Subject: EGLE Cover Letter and Detailed Comments_Kalamazoo River Superfund Site_OU5 Area 1

Comments on the Site Security Plan dated April 2022, the Construction Facilities Layout Plan, the Traffic Control Plan dated April 2022, and the Field Sampling Plan (FSP) – Remedial Reach dated April 8, 2022, Area 1 of Operable Unit 5 (OU5), Allied Paper Inc./Portage Creek/Kalamazoo

Allied Paper Inc./Portage Creek/Kalamazoo River Superfund Site Area 1 Post-Dredge and Backfill Confirmation Field Sampling Plan Remedial Reach

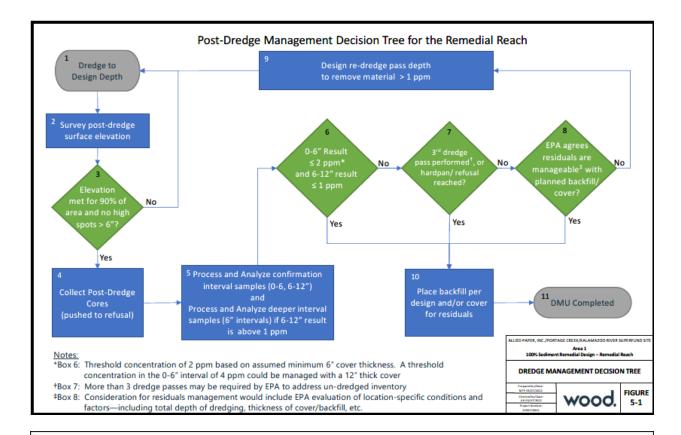
The FSP proposes collecting one aliquot from five subareas within each DMU and subareas range from 1,000 square feet (ft²) to over 4,000 ft². The FSP then proposes compositing the five aliquots for comparison to action levels established for this RD/RA, so DMUs range from 5,000 ft² to over 20,000 ft². However, the FSP also provides several examples of when confirmation sampling in a given subarea, or an entire DMU, would not be completed. The scenarios where confirmation aliquots would not be collected include the presence of high subgrade (stiff clay, dense gravel/cobble, or rock that prevents the Contractor from achieving the design dredge elevations) within the dredge confirmation cell; the inability to collect full 0 to 12-inch confirmation sediment core in one or more composite aliquot location; and, if there less than 80 percent recovery in one or more composite aliquot location. Text in the FSP also states that a minimum of three sample aliquots for each confirmation sample will be required, which suggests that in some instances a confirmation sample may not be collected at all (i.e., if less than three aliquots are collected).

Overall, the FSP falls short on describing how a simple random sampling strategy with a limited number of aliquots (i.e., five) over large DMUs (5,000 ft² to over 20,000 ft²) is sufficient to determine if the 'hot spot' has been removed. EGLE continues to have concern about the adequacy of the Area 1 RD/RA PDI in delineating the nature and extent of contamination and defining the depth to a clean surface. A standard confirmation sampling plan would consider the confidence in the design data and the objectives of the cleanup. The FSP does not provide data quality objectives, nor does it consider the adequacy of the data being used to develop dredge cuts and DMUs. Furthermore, the size of the DMUs is too large based on the cost estimates provided by the Respondents in the Area 1 Feasibility Study that were used in the Area 1 ROD which assumed one sample would be collected every 500 ft².
